# Technical Service Information

## FORD AODE/4R70W ENGAGEMENT CONCERNS AND OR EARLY OR LATE SHIFT PATTERNS

### SERVICE INFORMATION: 93-17-8

Figure 1

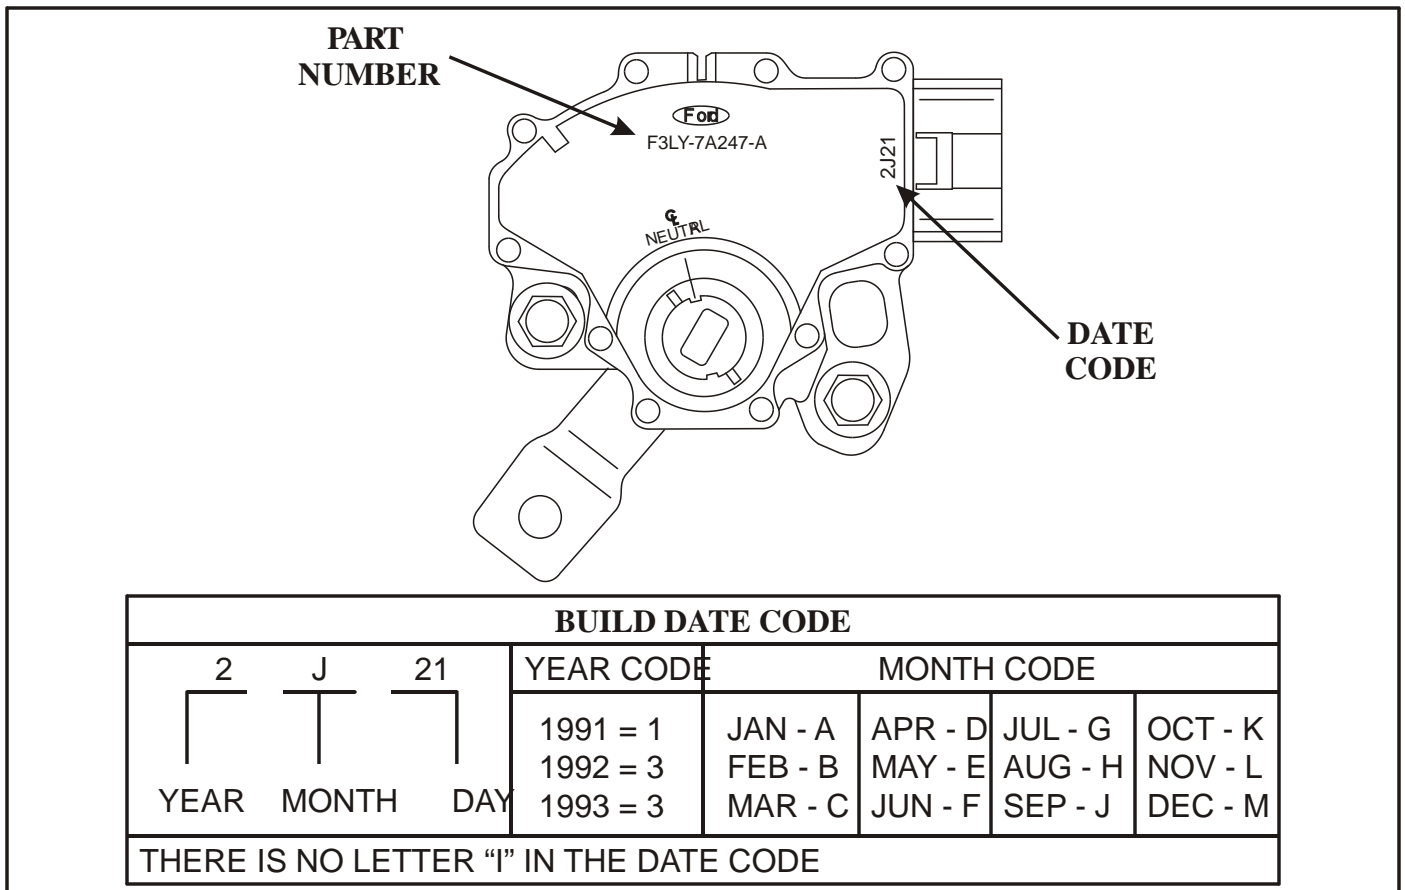
**COMPLAINT:** Some 1993 Crown Victoria, Grand Marquis, Mark VIII, and Town Cars may exhibit soft or harsh engagement and/or early or late shift pattern complaints.

**CAUSE:** The cause may be, internal contamination of the Manual Lever Position Sensor (MLPS).

Replace the MLPS with a revised service level sensor that is more resistant to internal contamination (See Figure 1). NOTE: WHEN REPLACING THE MLPS ON THE AODE/4R70W TRANSMISSION FOR ANY REASON, DO NOT USE MLP SENSORS

**CORRECTION:** WITH DATE CODES OF 2521 TO 2L06. The date code is stamped on the outer cover of the MLPS, as shown in Figure 1. Use the service part numbers listed below.
